**From:** Lindsey Ozbolt  
**To:** ["Daniel Rowe"](#)  
**Subject:** RE: 1705 E Lake Sammamish PI Se Trail  
**Date:** Thursday, February 16, 2017 3:46:32 PM

Reference number in the 60% plans would be we are # 352 of Segment B  
The trail runs through our property as many have.

Your email has been added to the SSDP2016-00415 Segment 2B project file.

DRAWING NUMBER: **A1.0**  
 OF DRAWINGS

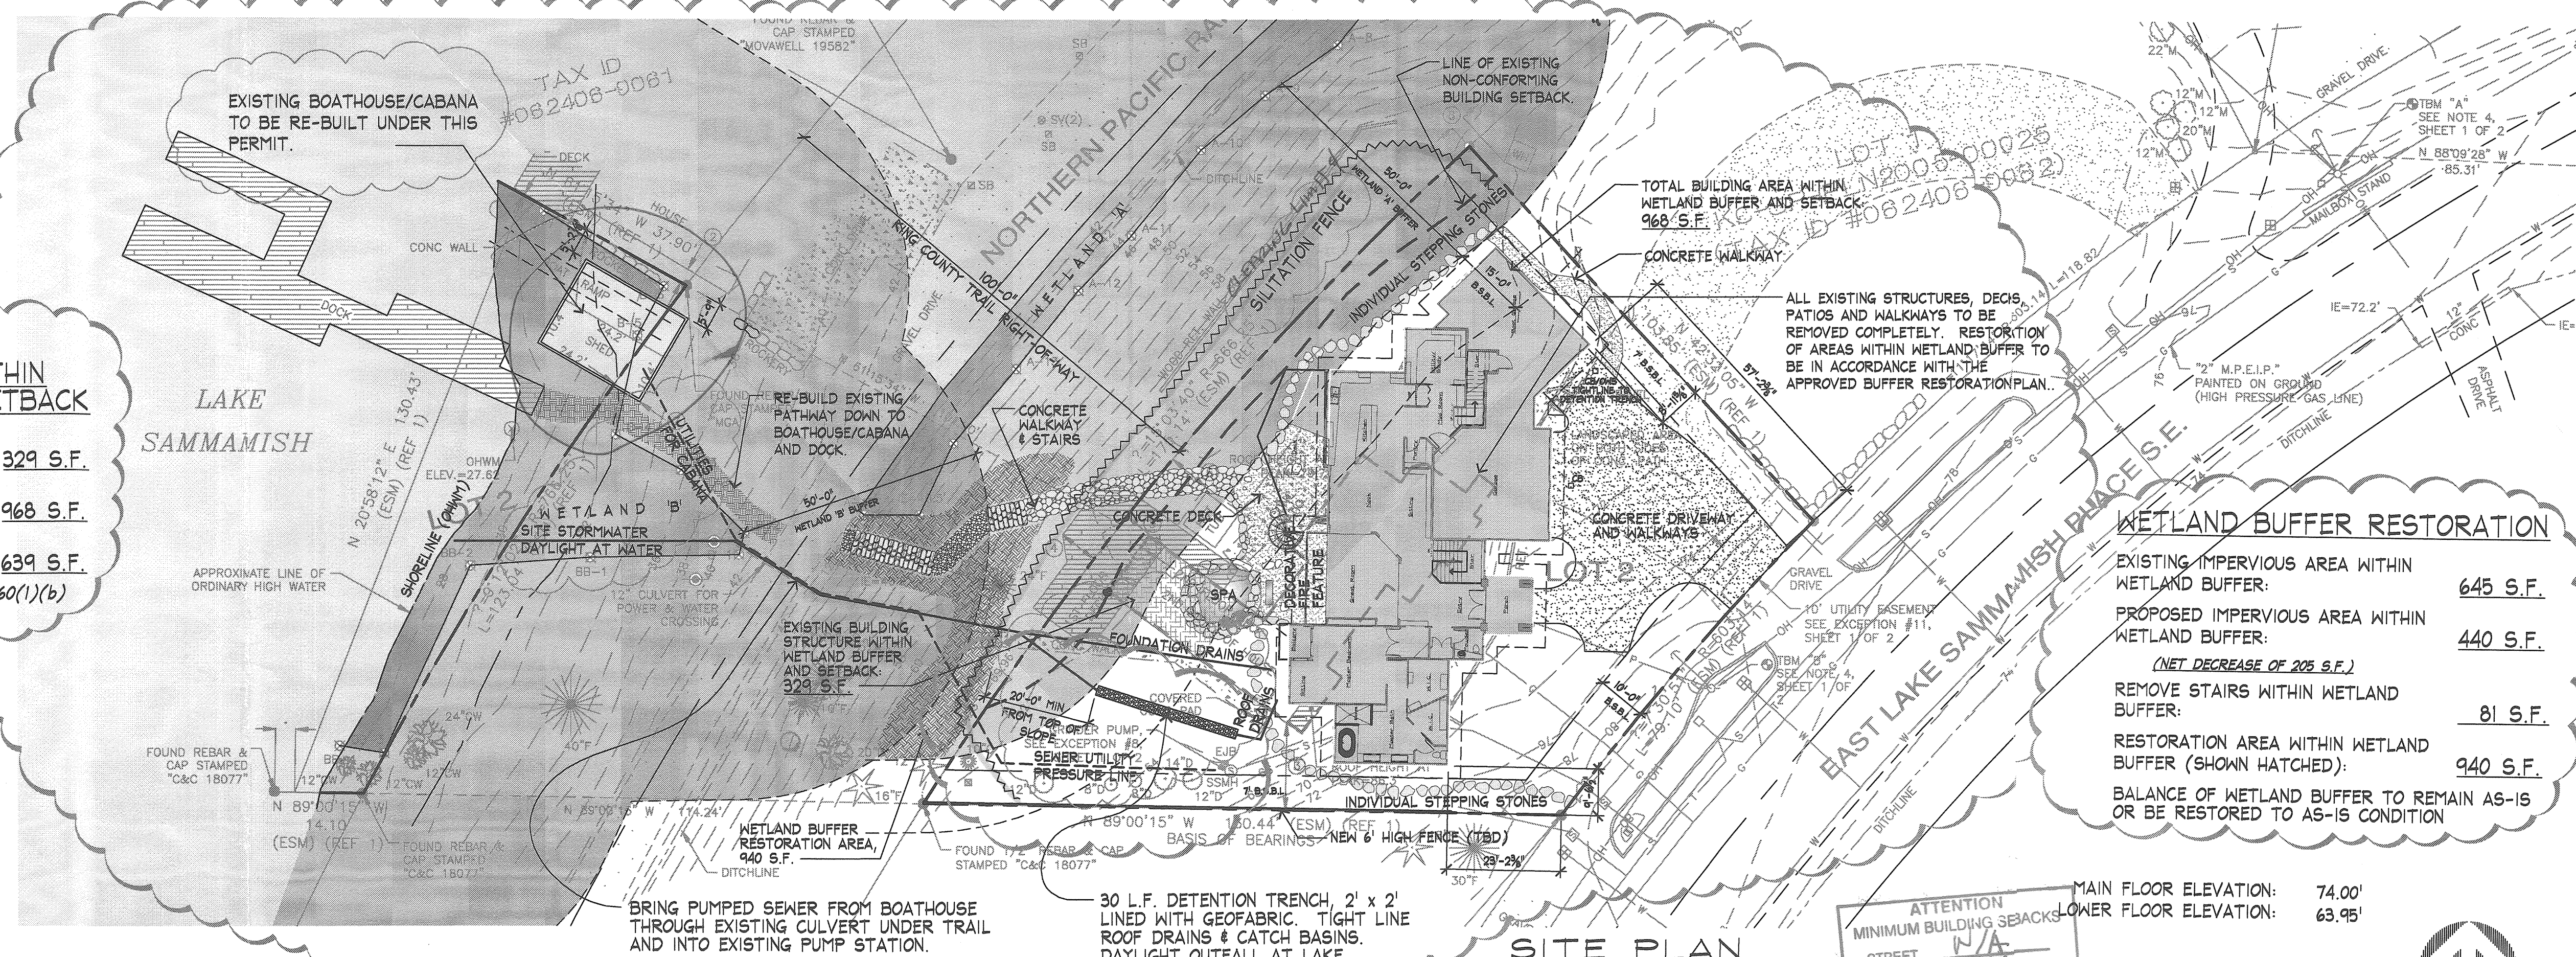
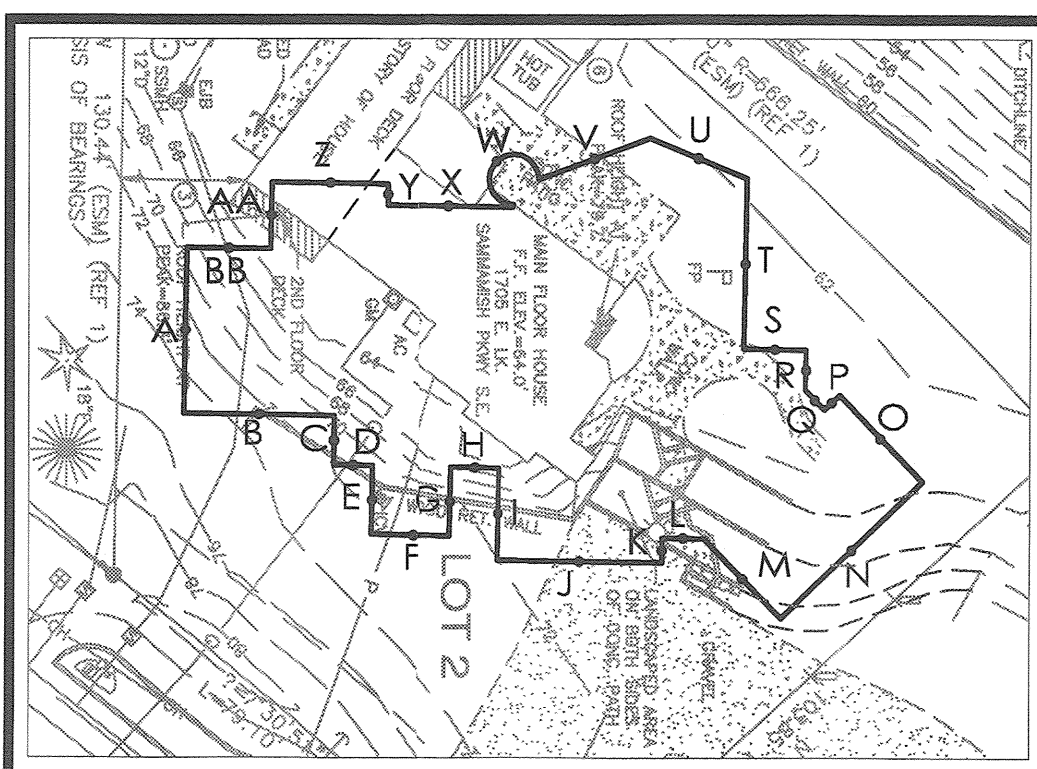
The 60% plans for show our stairs coming down from the house where the new construction is and going to be. Simply we want to make sure that when they do take a couple feet from that area that the landing is put back so we still have access to our lake house. The 60% plan shows the stairs but no real detail yet of the the landing as per the permit.

You'll see the walkway that was built from the trail to the lake house. This can be seen as part of the lake house permit as well. We would request that our access stays the same as with our permit. The 60% plan shows that our neighbor to the south and us will share a new access. I'm sure it's to save money however our permits show the access as it is now. We would respect that this does not change. The permit shows where we had to rebuild the existing pathway from the trail to the lake house.

I do not see on the 60% plans where it show's my utilities crossing the trail. Please see on the lake house permit where the utilities cross the trail from the upper lot to the lake house. We are notify the city of these utility lines. Please be sure they do not cut these lines etc. Our lake house has full power and water and sewer with permits.
